| Model: Model J-C2 | | Date: 29-Mar-05 | No.: RB178001 |
| Subject: Firmware Release History (Engine) | | Prepared by: H.Taguchi | |

This RTB has been issued to announce the firmware release information for the engine.

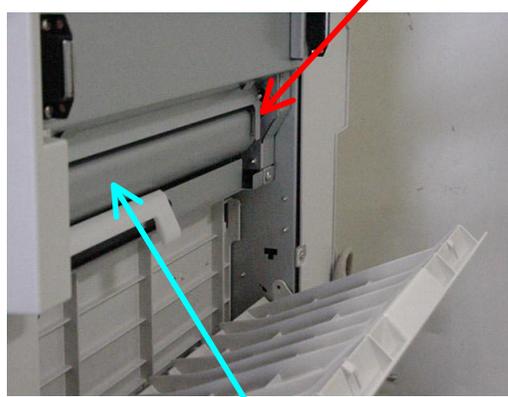
- The edges of folded sheets are not parallel (50–100mm booklet skew), and a loud sound can be heard from the Booklet Finisher.

When the engineer removes the shipping tape at installation, he/she pushes the grounding plate [A] and bends it by mistake [B]. As a result, this interferes with the movement of the guide plate [C].

- At machine installation:**
Do not press [B] the grounding plate when you remove the shipping tape.
 - If the symptom occurs in the field:**
 - 1) Check the grounding plate to see if it is bent.
 - 2) If the plate is bent:
 - 1) Bend it back as follows:
 - Direction: Away from the paper path
 - Amount: Target **2-3mm** (max. 5mm)
- OR**
- 2) Replace the grounding plate.

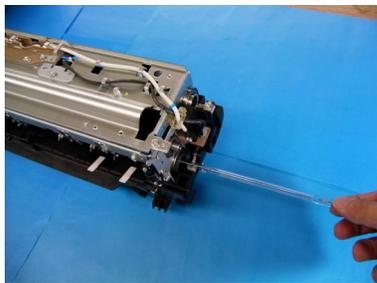
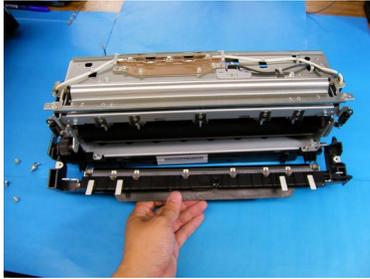
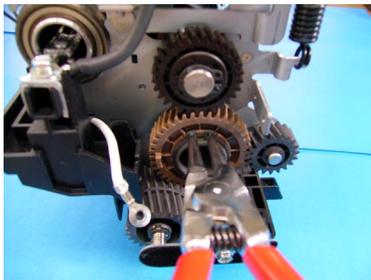
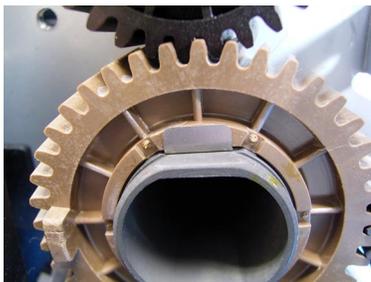
The space between the pressure roller and the gear for the pressure roller causes the sound under a specific condition.

Please attach a spacer (P/N B1809004) according to the following procedure.

6. Insert the spacer (P/N B1809004) all the way.

| Subject: Wrong paper add message | | Prepared by: H.Taguchi | |

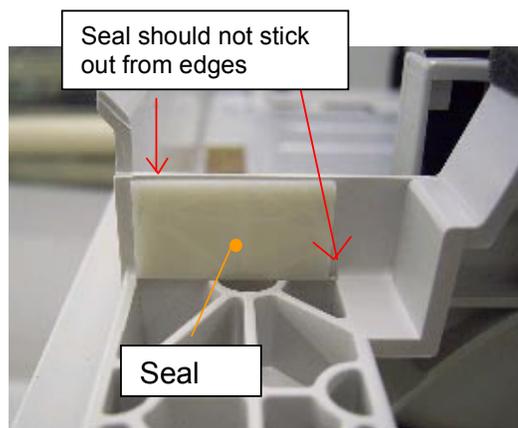
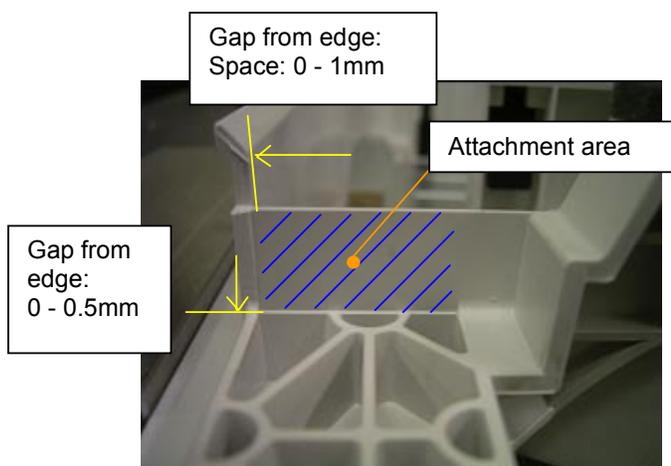
The “Add paper to Tray1/Tray 2” message is displayed when the machine warms up to the Ready condition, even when there is paper inside Tray 1 or Tray 2.

When the tray is pushed in, the rear side of the tray does not push the pick-up lever. As a result, the machine cannot detect the paper in the tray.

Attach a seal to the rear side of the tray, which will ensure that the pick-up lever is pushed and the machine detects the paper.

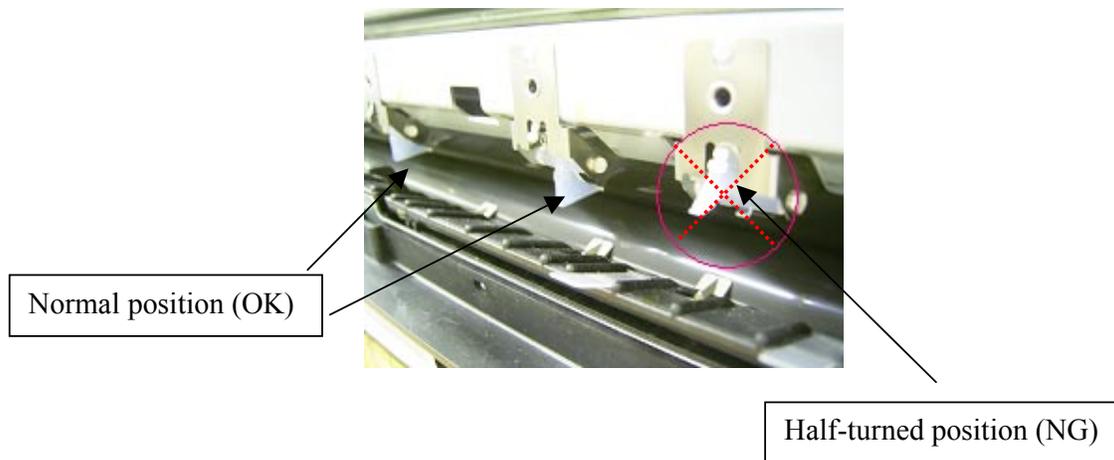
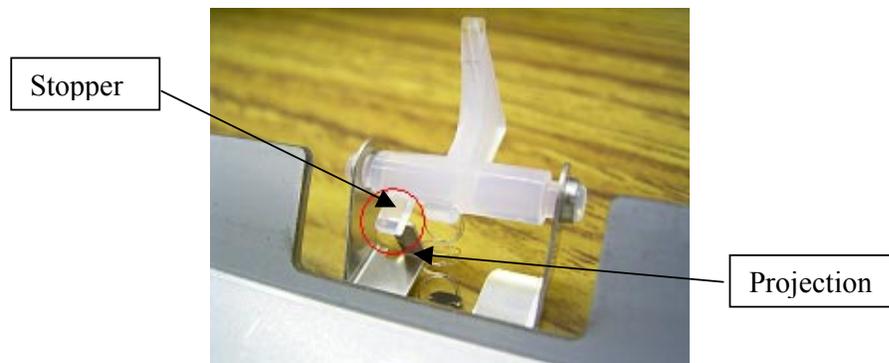
The pick-off pawl damages the fusing belt when the operator removes jammed paper from the fusing unit.

The user does not turn the knob when they remove the jammed paper. As a result, the pick-off pawls are locked at the half-turned position and damage the fusing belt.

Shorten the pick-off pawl stopper (see the procedure below).

1. Remove the upper cover (4 screws).
2. Remove the pick-off pawl brackets (2 screws each).
3. Cut 0.5 mm off the edge of the pick-off pawl stopper (5 pick-off pawls).

Important: After you cut the stopper, rotate the stopper and make sure it contacts the projection on the bracket.

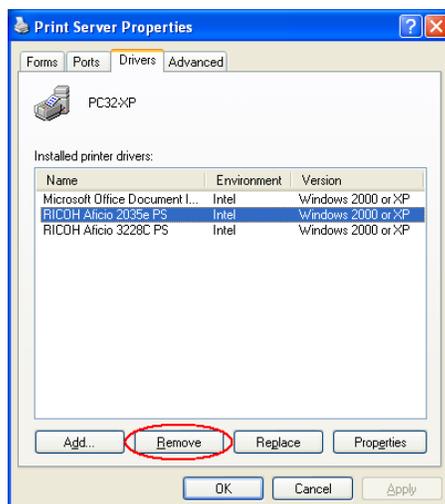
The cause is that both model A-C3e/f and J-C2 drivers use plugin modules of the same name. These names are supposed to be different, but accidentally, the same names were used.

- 1) "RA45PSUI.DLL" UI module. (displays the UI.)
- 2) "RA45PSRE.DLL" Render module. (renders print jobs.)

If both drivers are installed on the same PC, the plugin module names will conflict. Due to the conflict some Job Types are unavailable.

Note: Before installing the fixed driver, please completely delete the old driver for model J-C2 and A-C3e/f (File - Server Properties - Drivers tab). Then install the new driver for model J-C2 and A-C3e/f.

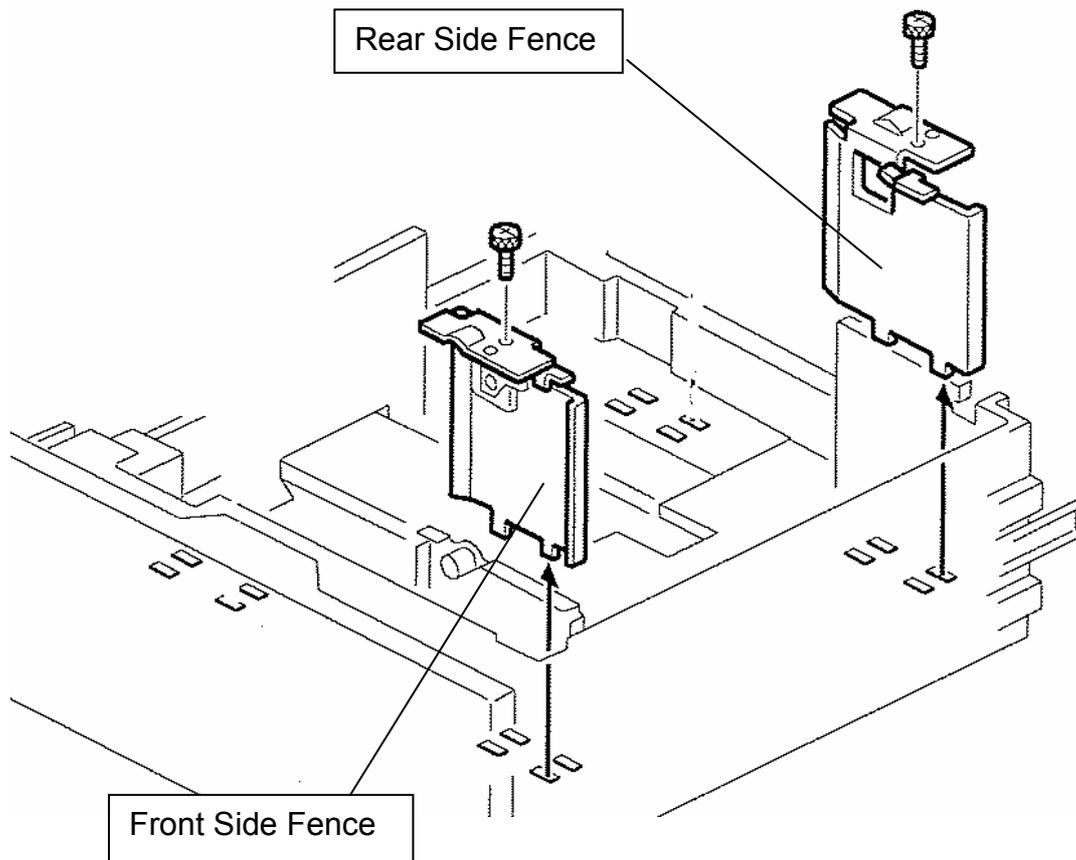
Note: G5692640 → B6002640, G5692650 → B6002650 O/O These changes have been applied due to vendor change.

1. Replace the front side fence with **B1809902** (production line temporary solution).
- Or,**
2. Replace the front side fence and rear side fence with **B6002645** and **B6002655**.

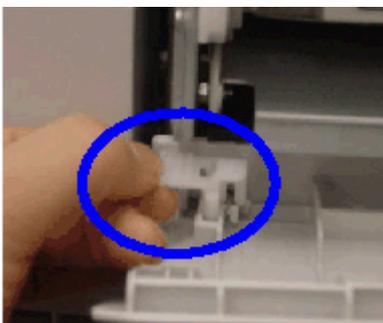
Add a stopper to the area shown below. This will increase the durability of the shaft.

3. Attach the new stopper.

- Line up the small projection on the stopper with the groove in front of the cover/shaft.
- Attach the stopper so that the shaft is fixed firmly in place.
- Push the stopper in until you feel it click into place.

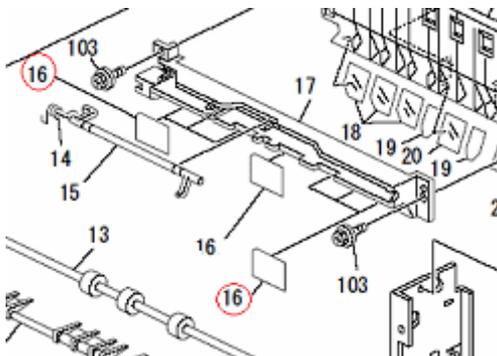
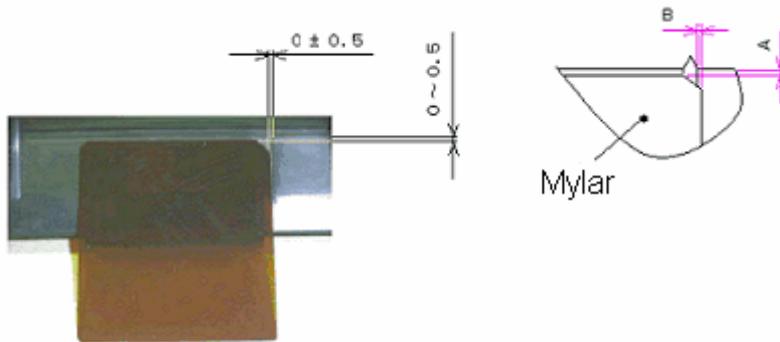
The junction gate Mylar at both ends of the duplex inverter unit bends. This happens most often when using paper that has a high stiffness and has a large curl. The paper hits the Mylar and causes it to bend.

Note: The jam occurs when the paper is guided to the inside of the bent Mylar. Clearing this type of jam with too much force causes further deformation of the Mylar and increases the jam occurrence.

1. Replace the junction gate Mylar (index #16) at both sides of the duplex inverter unit with **P/N B1809005**.
2. If any of the other junction gate Mylars are bent, replace all junction gate Mylars.

1. Clean the attachment area with alcohol.
2. Line up the top edge of the Mylar with the ridge of the guide plate, as shown in the photo (**0 to 0.5mm** from the ridge).
3. Line up the right edge of the Mylar with the groove, as shown in the photo (**-0.5mm to +0.5mm** from the groove).
4. Make sure the top edge of the Mylar is not sticking out from the ridge of the guide plate.
5. Make sure the entire attachment surface of the Mylar is attached firmly to the guide plate (no wrinkles, no bends).

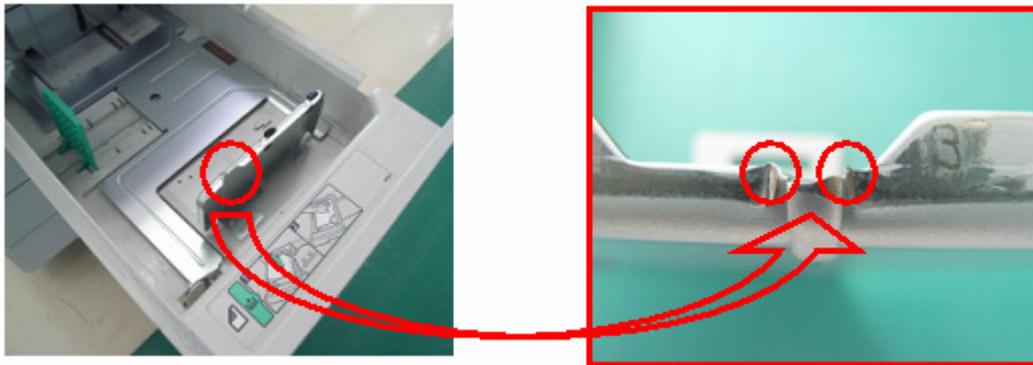
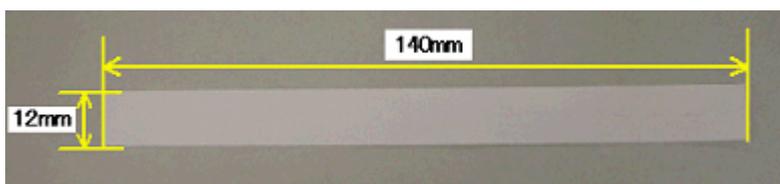
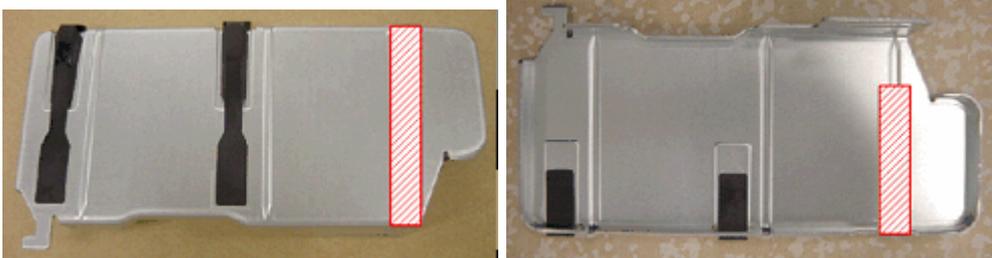
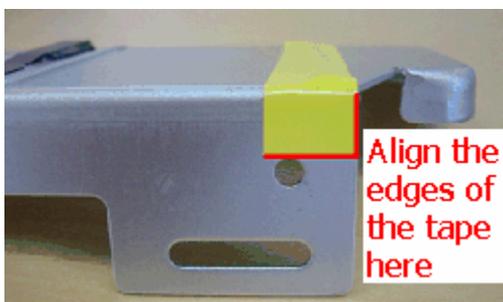
There are small burrs on the top edge of the side fence. In a small number of cases, this may cause injury if touched.

Burrs, which form as a normal part of the sheet metal stamping process, can sometimes be as prominent as those shown in the photo.

Although only some side fences may have burrs like those shown in the photo, please attach the following protective tape at the next service visit.

- On the bottom of the side fence, make sure to align the two edges of the tape as shown in the photo below.
- Make sure to attach the tape firmly so that it does not wrinkle or peel off. **Make sure the tape completely covers the area with the burrs.**

Fig. 1: The old BK drum motor (AX060288).

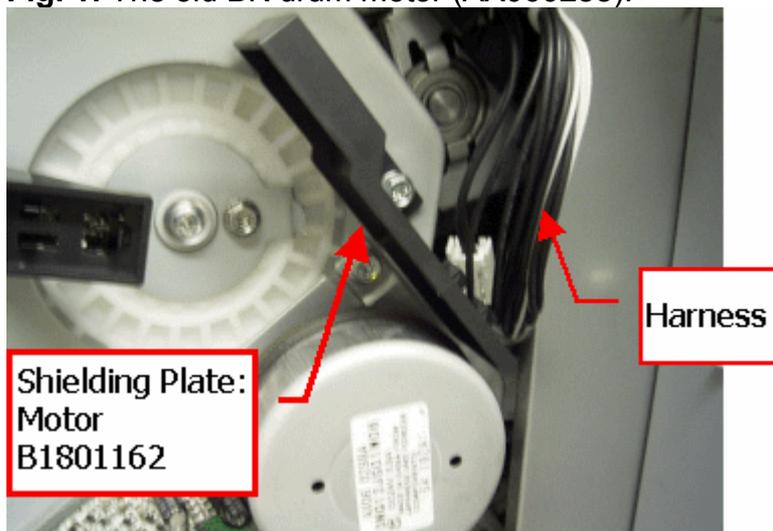
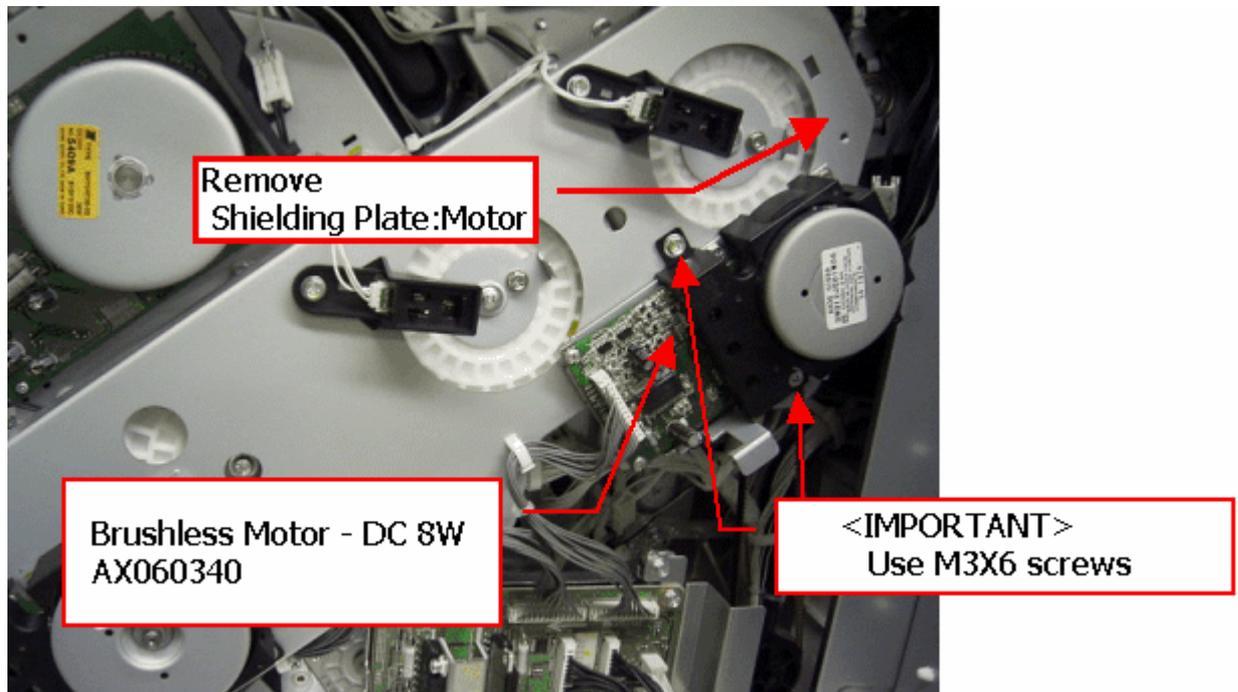
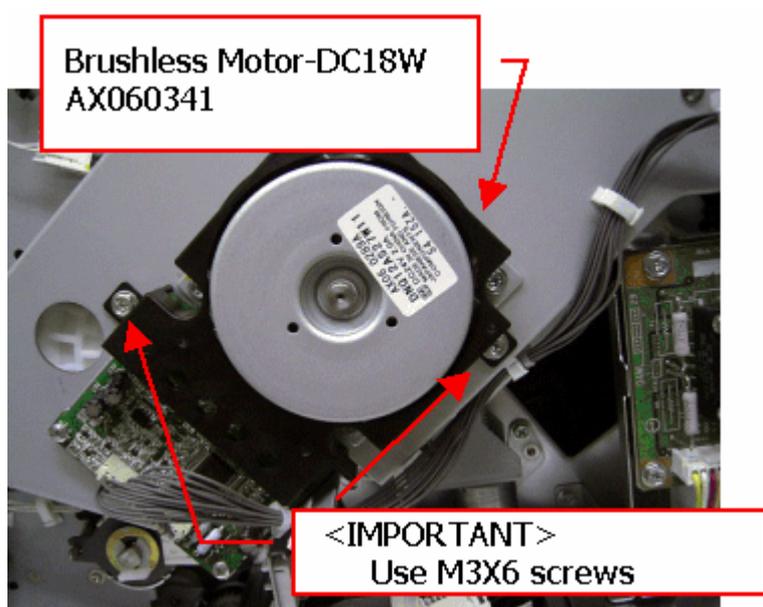
- Only use **M3x6** screws to attach the cover. If you use any other screws, they will touch the drum gear.
- When you attach the BK drum motor (AX060340) for the first time, remove the shielding plate (B1801162) that is already attached.

Note: The shielding plate is not listed in the Parts Catalog (due to an error).

Photo A

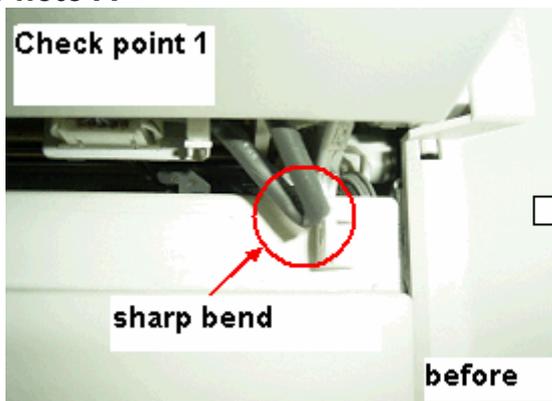
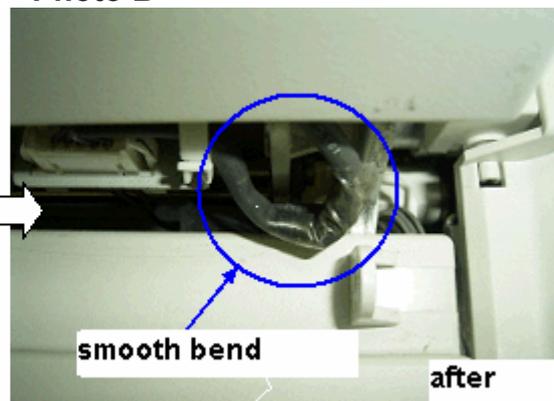
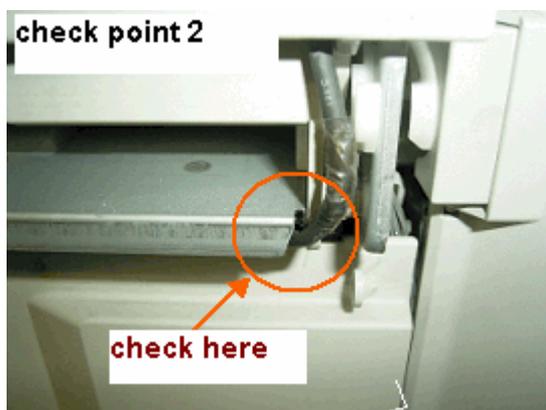
- Make sure there are no sharp bends in the harness (like the one shown in **Photo A** below).
- Make sure that the harness passes through the cutout in the guide plate smoothly when the bypass tray is opened/closed (as in **Photo C** below).
- Make sure the cover is not sticking out at all when the cover is closed (as in **Photo D** below).
